**TM-F22-0009 SUMMER BROOK UNIT 2 FINAL MAP
EXHIBIT A - ASSESSOR'S PARCEL MAP**

TM-F22-0009 SUMMER BROOK UNIT 2 FINAL MAP
EXHIBIT C - FINAL MAP FOR SUMMER BROOK UNIT 2

TM-F22-0009 Exhibit F
Conditions of Approval Conformance Verification for Summer Brook Unit 2 Final Map

TM-F22-0009 is the Final Map application for Phased Tentative Subdivision Map TM07-1440-R-2 (Summer Brook Unit 2, Phases 3 & 4). The below Conditions of Approval (COA) were reviewed and approved by the Planning Commission in 2018.

cta Engineering & Surveying
 SHEET 2 OF 5

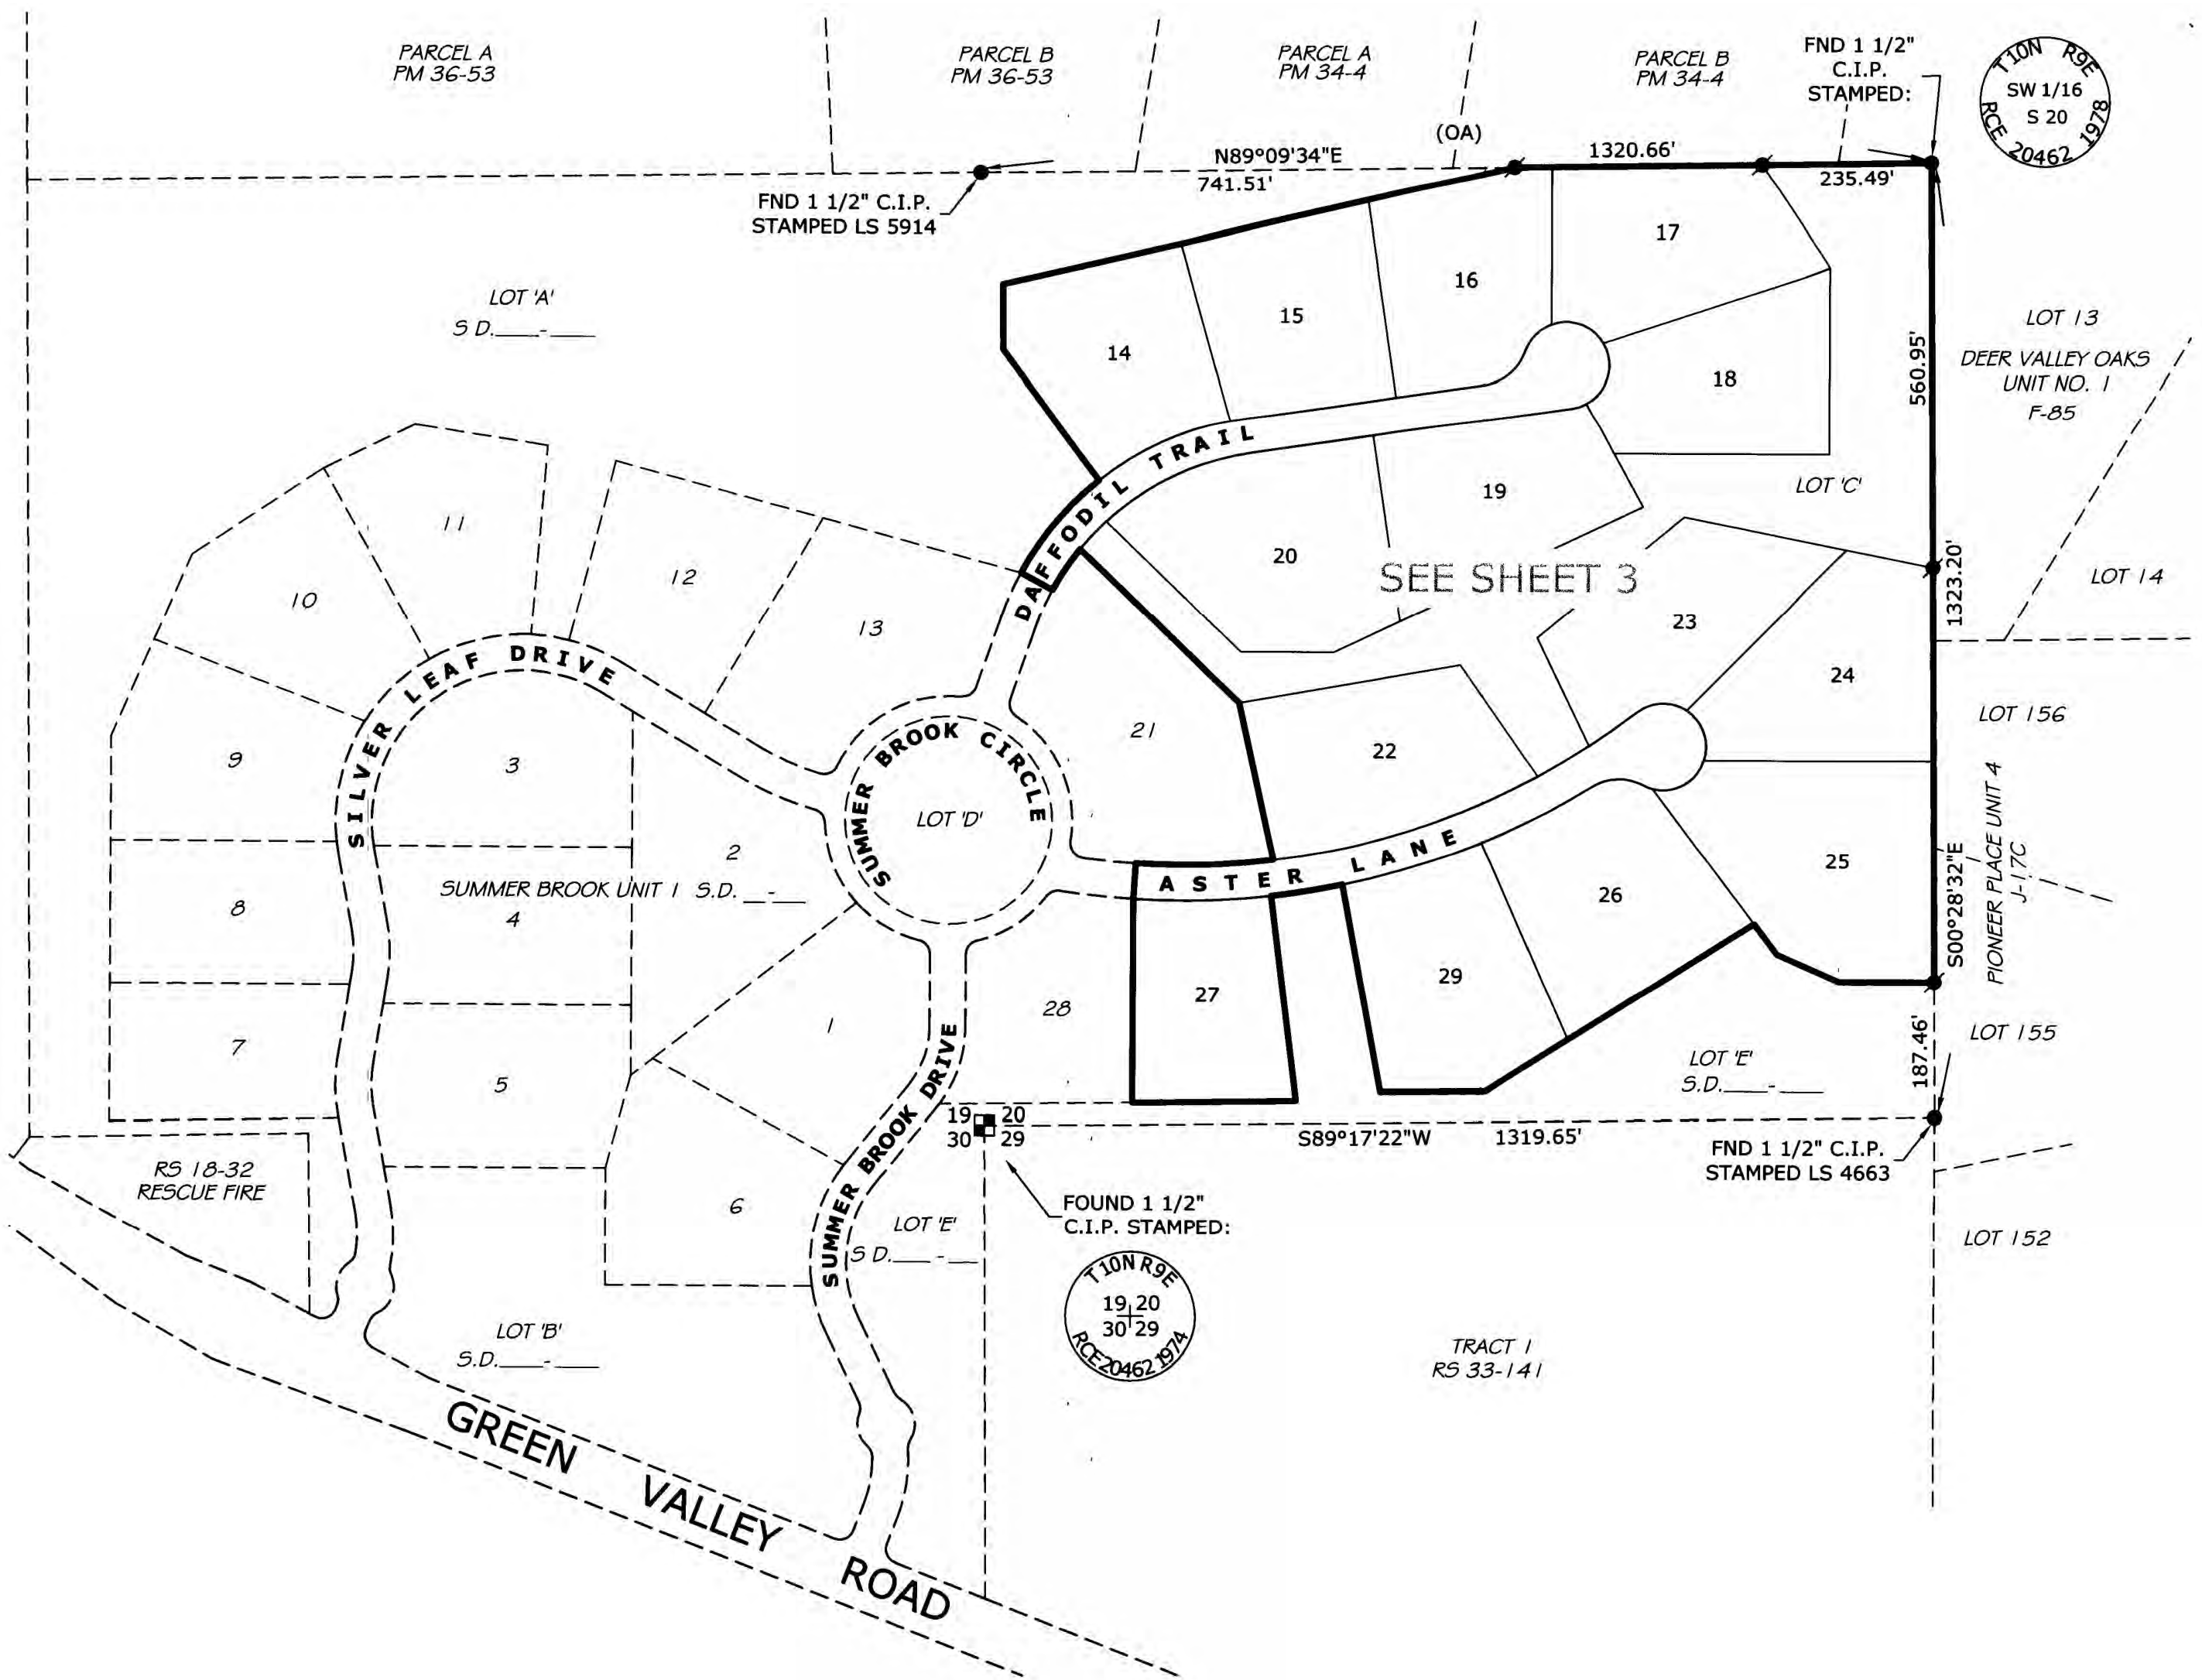
11. All open space lots shall be dedicated prior to filing of a Final Map for any phase. Planning Services shall review and approve the open space lots prior to filing the Final Map.

Staff Verification: Planning Services reviewed relevant documentation, including Note No. 3 on Final Map Sheet 2, HOA formation documents and draft CC&Rs and determined dedication of open space lots is consistent with this condition. Therefore, the project is consistent with this condition.

cta Engineering & Surveying
 SHEET 5 OF 5

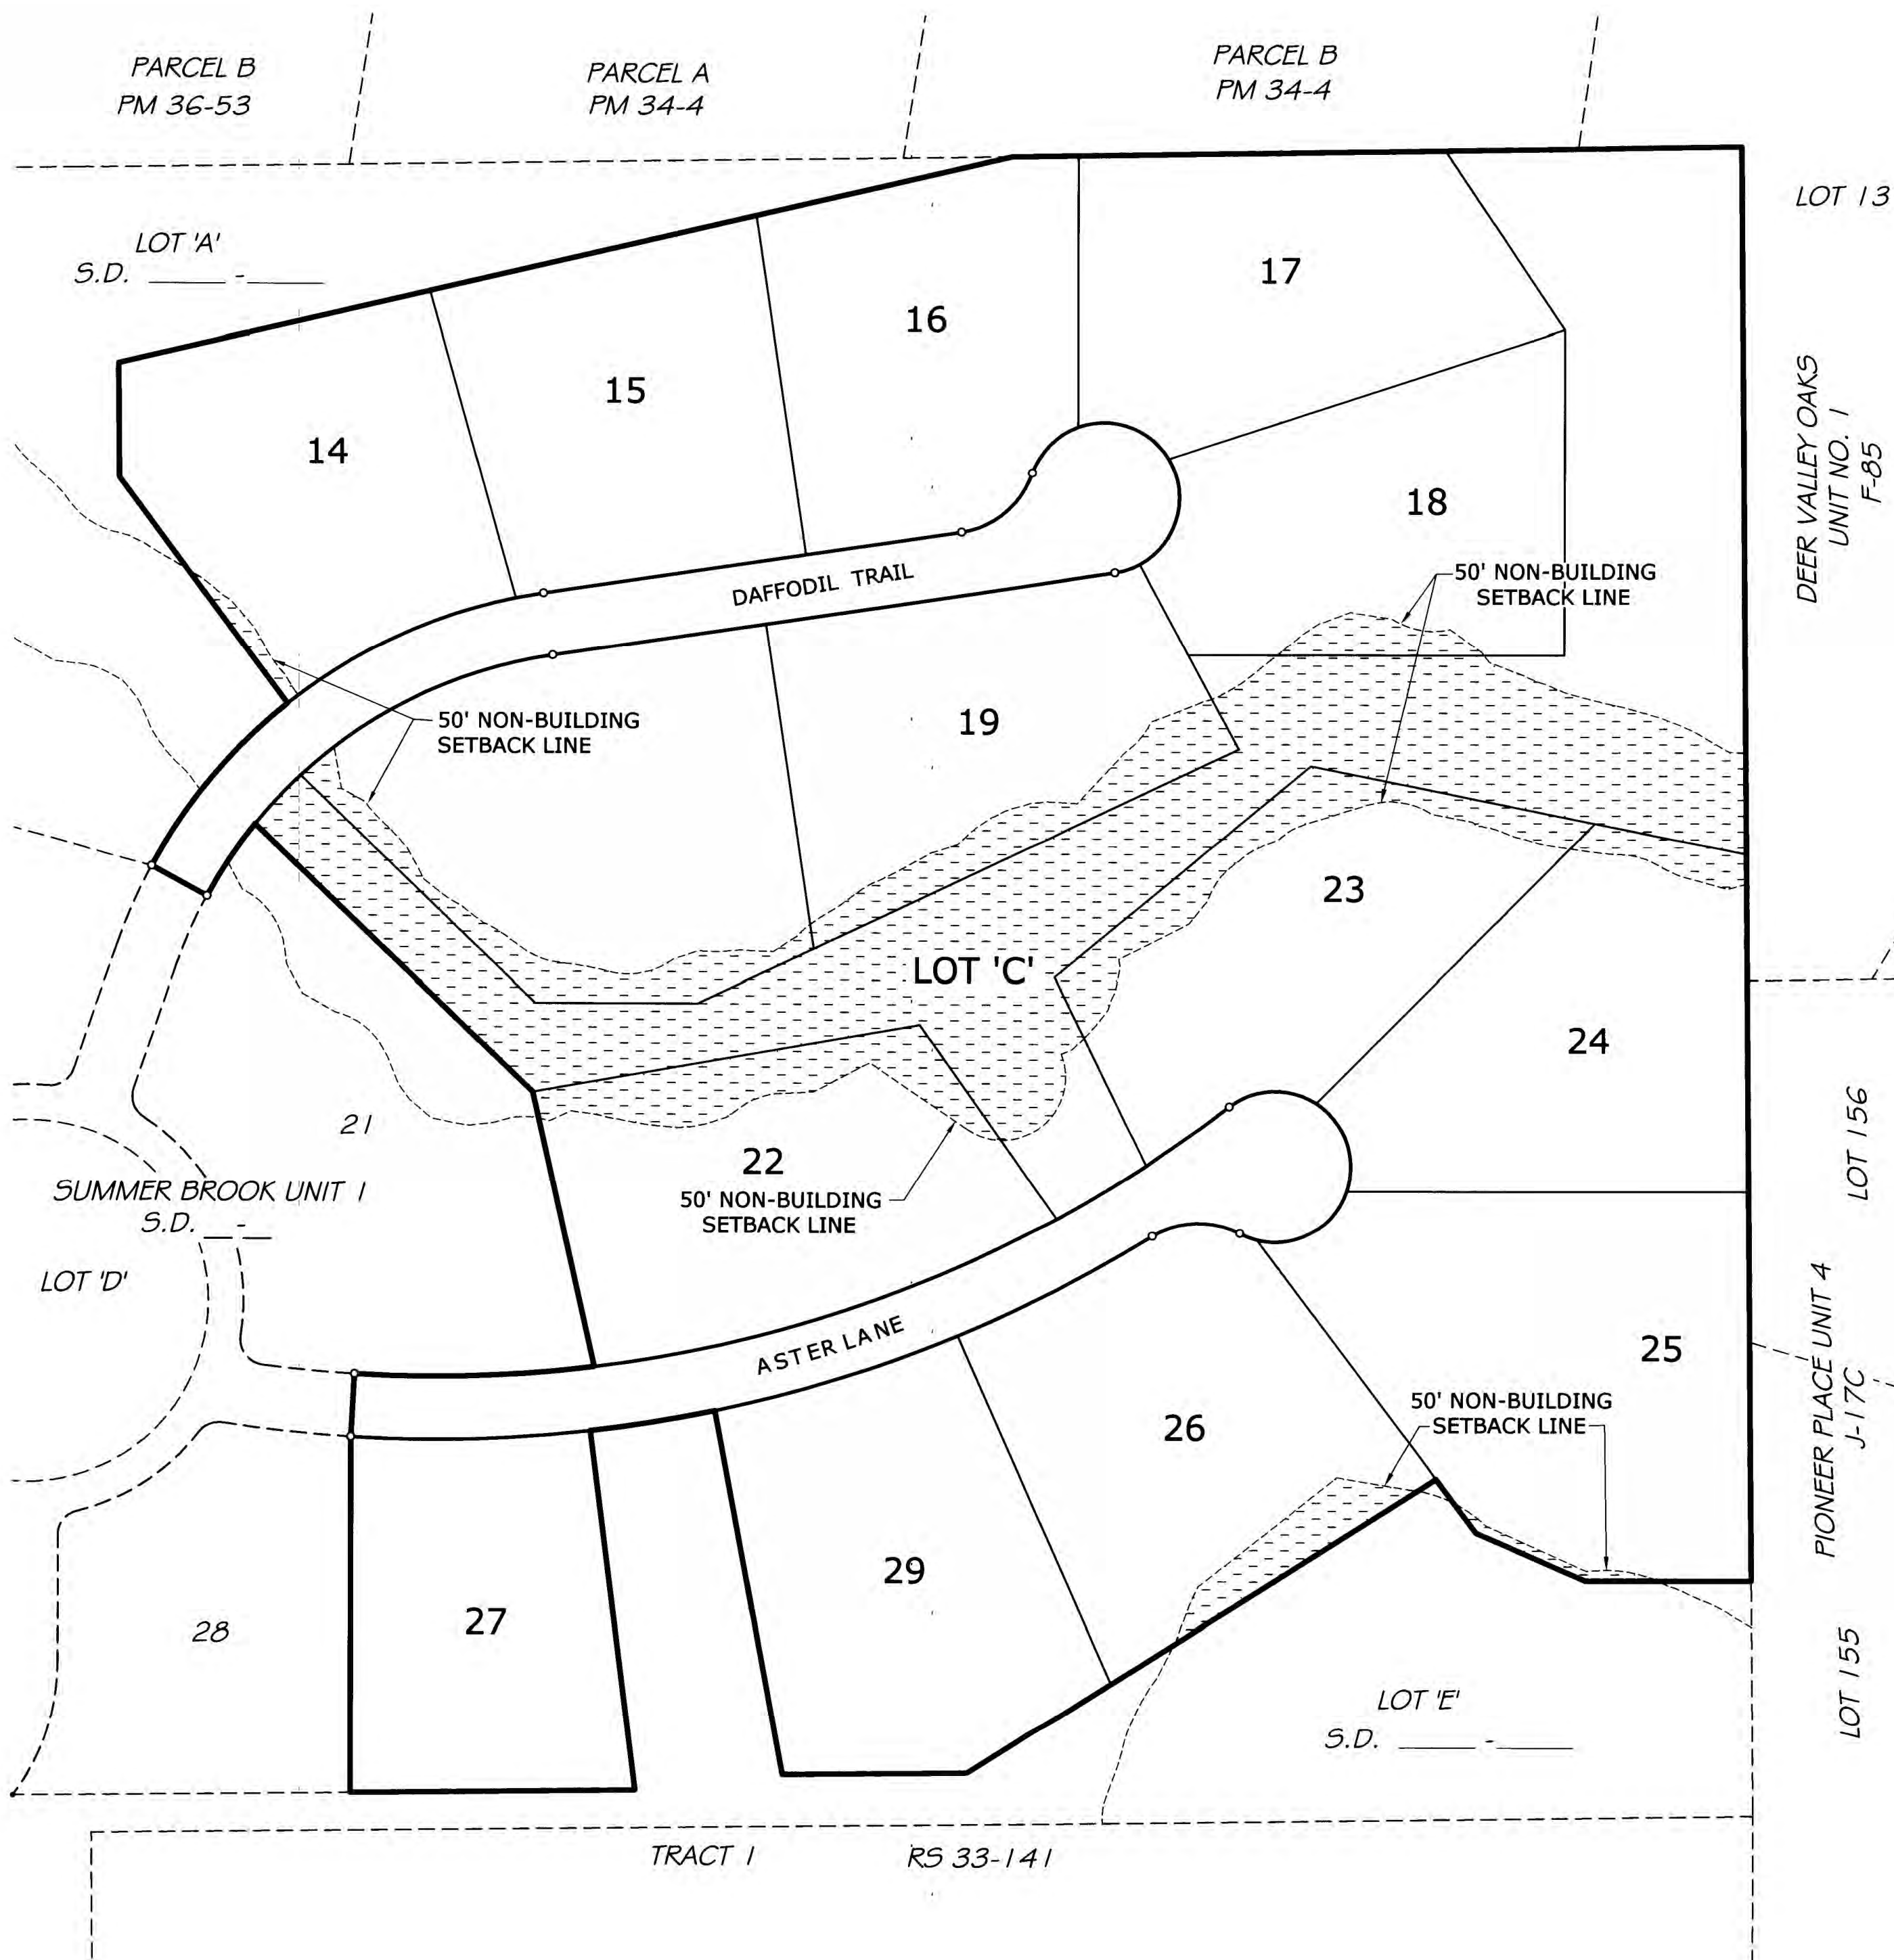
13. The Final Map shall include a 100-ft non-building setback from all ponds and a 50-ft. non-building setback from all wetlands at the subject site as delineated on Exhibit F. Planning Services shall review and approve the setbacks prior to filing the Final Map.

Staff Verification: Planning Services verified Non-building setbacks are shown on the Informational Sheet of the Final Map as required. Therefore, the project is consistent with this condition.
